COA Review Comments

Euclid / Wilson Storm Drain Improvement Project, 90% Submittal
Subproject I.D. No. 5789.035

<p>Project Item: 90% Design Plans and Report / Euclid_Wilson SDIP</p> <p>Data Receiving Date: 2/1/2011</p> <p>Comments Submitted Date: 2/15/2011</p>

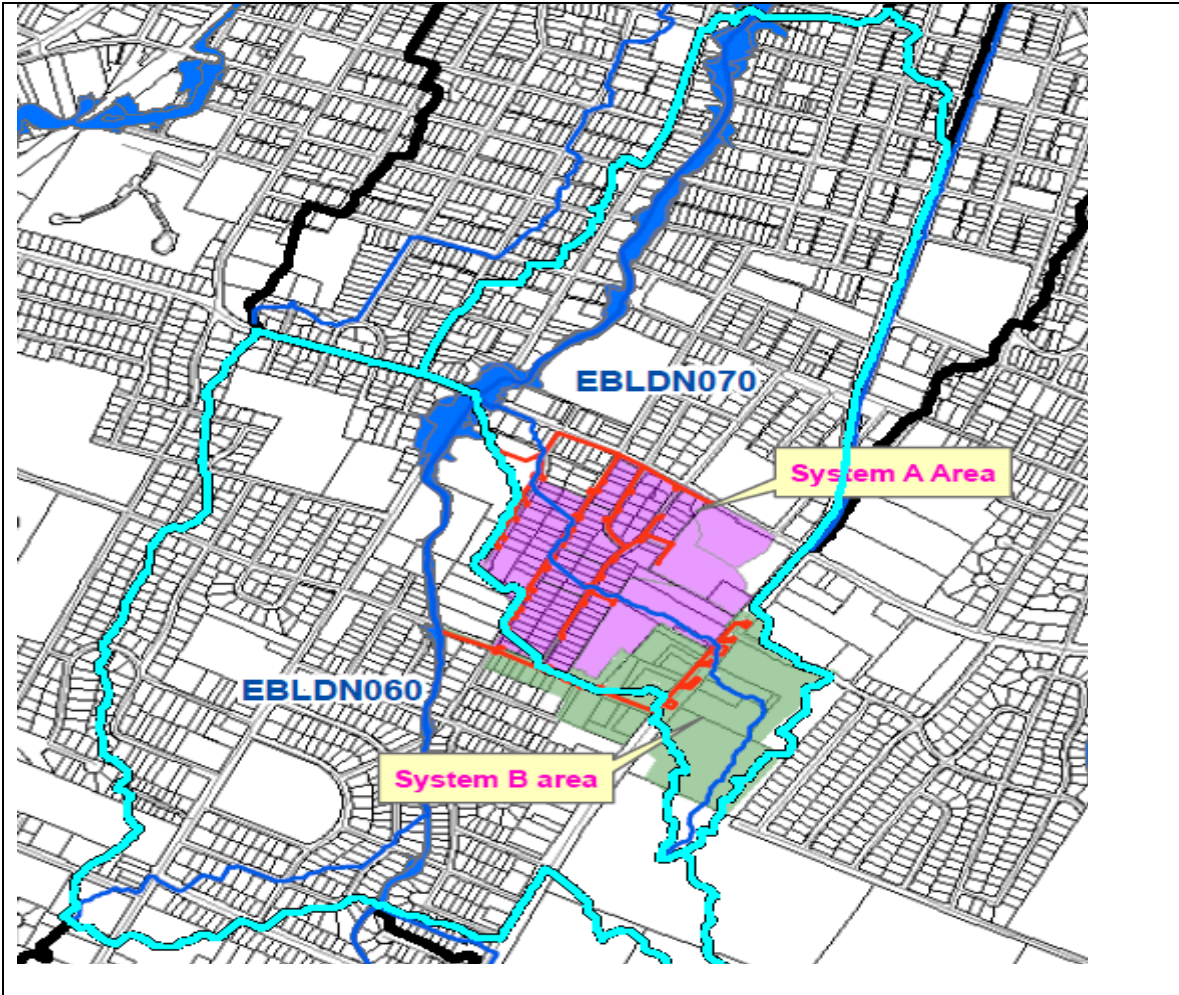
Estimated Potential Savings: N/A			
PS/PM Response to #3:			
PS/PM Decision on VE's Recommendation:	Agree: <input type="checkbox"/>	Disagree: <input type="checkbox"/>	Partially Agree: <input type="checkbox"/>
VE Comment #4: <p>Similar to other storm-drain improvement designs, the proposed hydraulic grade lines (HGL) within the project area are below street level under a 100-year storm event. As a result, the longest flow path for Tc estimation between the pre-development and the post-development conditions should be dramatically different. The City's FIS model assumes that under the 100-yr flood, most storm-drains are surcharged and the Tc calculation is based on surface runoff with the longest flow path determined primarily by topography</p>

(see the red line shown in the map below). This assumption appears to be reasonable for existing conditions for the 100-yr storm event and is supported by the fact that local storm drains were undersized and local flooding has been severe in this area. However, as a result of the proposed design, the Tc flow path should be changed accordingly and the storm-drain network becomes a major portion of the longest flow path.

However, the report indicates that the post-project Tc is reduced by only 1.06 minutes as compared with the pre-development condition and there is no adverse impact from the project. A brief check over the available Tc calculation data indicates that the Tc estimation by the design engineer for the **pre-development conditions** is not appropriate. The 90% design report states “the time of concentration used for the Euclid-Wilson area (consistent with AECOM’s PER approach) was to use the longest travel time of the System A and System B StormCad models. System A is the longest and existing conditions travel time is computed to be 15.87 min and the 90% design proposed conditions travel time is computed at 14.81 min.” In fact, part of the storm water runoff from System B as well as from the upstream drainage area on the east side of the S. Congress was used to flow through System A area and can not be separated from System B under predevelopment conditions. By using the floodplain model, the Tc has been estimated to be approximately 25.53 minutes [sheet flow length has been adjusted to be the same as TCB’s (150 ft) for comparison purposes] using the original FIS model and flow path while the 90% design report shows the pre-development Tc is about 15.87 minutes.

The VE team recommends that the design team re-check the **pre-development** Tc calculation to reflect the **existing** flow conditions and take the flow travel time in the area on the east side of S. Congress Ave. into account before comparing with post-development flows. If adverse impact exists, proper mitigation design is needed to meet the City’s “no adverse impact” requirements.
